TO: Development Review Board
FROM: Scott Gustin *SG*
DATE: November 5, 2013
RE: 14-0375CA; 188 North Prospect Street

Request: Construct rear addition, install two sheds, and construct new rear gravel parking area.

Ohavi Zedek Synagogue
Kitchen Renovation/Addition
BURLINGTON, VERMONT

PROPOSED
SITE PLAN, 188 NORTH PROSPECT ST.
① 1" = 40'-0"

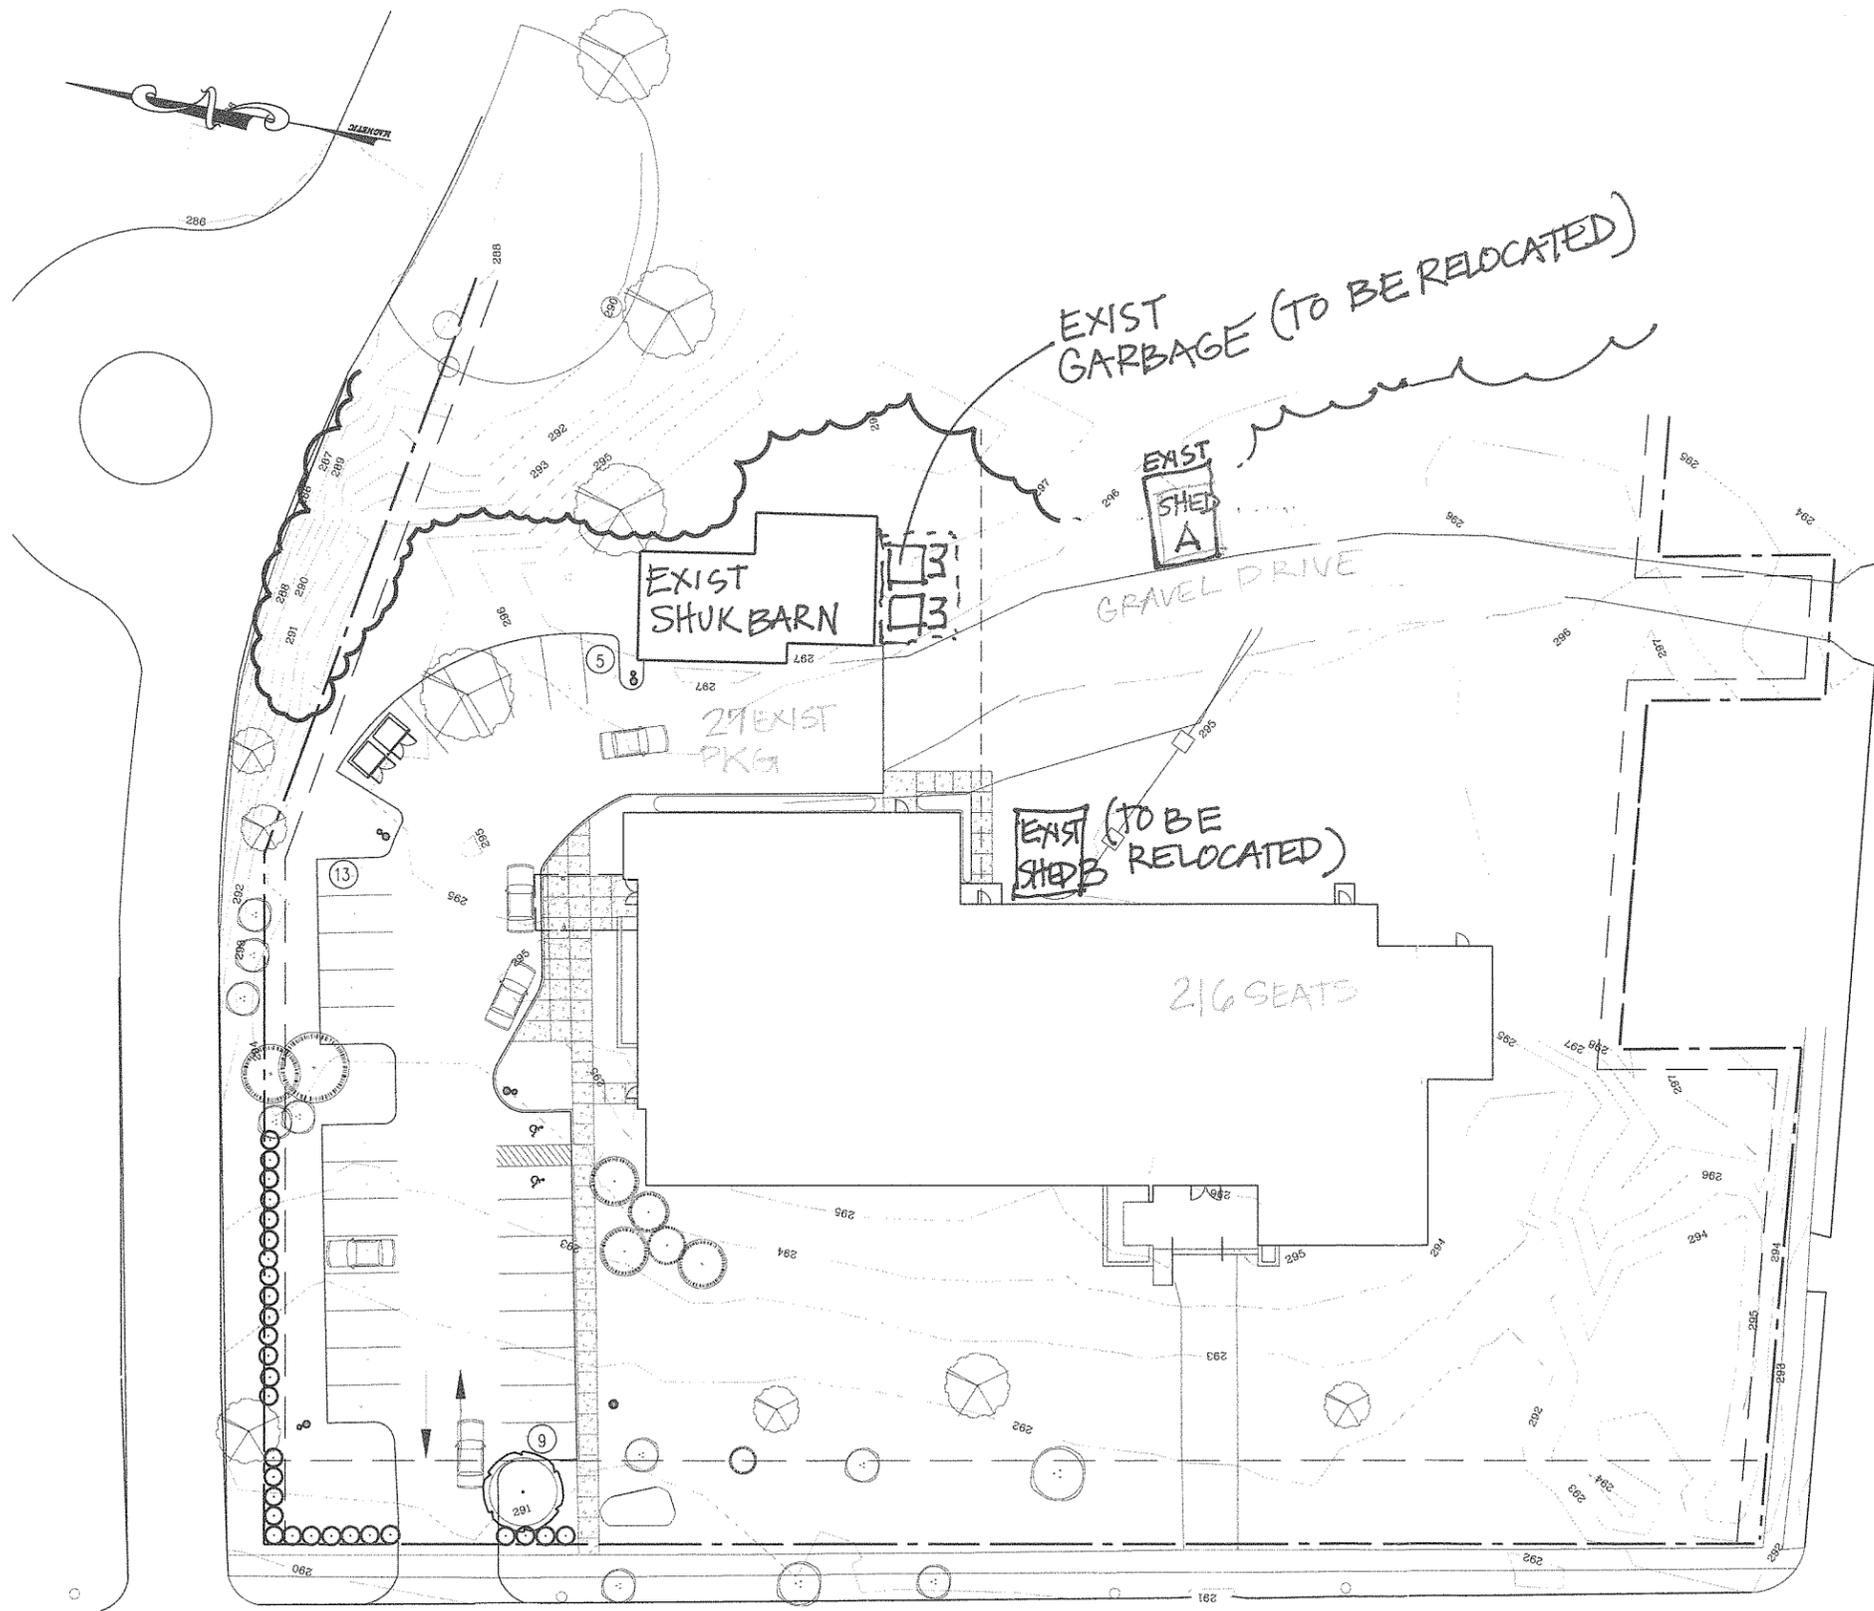
The proposed addition will not affect any important natural features. The proposed gravel parking lot, however, will require partial clearing of the wooded area behind the building. Clearing limits are not depicted on the site plan and must be. **(Affirmative finding as conditioned)**

The gravel parking area will not contain striped parking spaces; however, it will be sufficiently wide enough (60') to contain room for two rows of 18' parking spaces and a 24' center circulation isle. The 24' circulation isle will allow vehicles to enter and exit the parking area while driving forward. Curb stops are needed to keep vehicles entirely within the parking area and to better define parking spaces. **(Affirmative finding as conditioned)**

1. **Prior to release of the zoning permit**, revised project plans reflecting the following shall be submitted, subject to staff review and approval:
 - a) Tree clearing limits clearly depicted on the site plan; and,
 - b) Depiction of curb stops within the new parking area, or in lieu of gravel the parking lot may be paved.
2. **Prior to release of the zoning permit**, the applicant shall obtain written approval of the Erosion Prevention and Sediment Control Plan from the Stormwater Administrator.
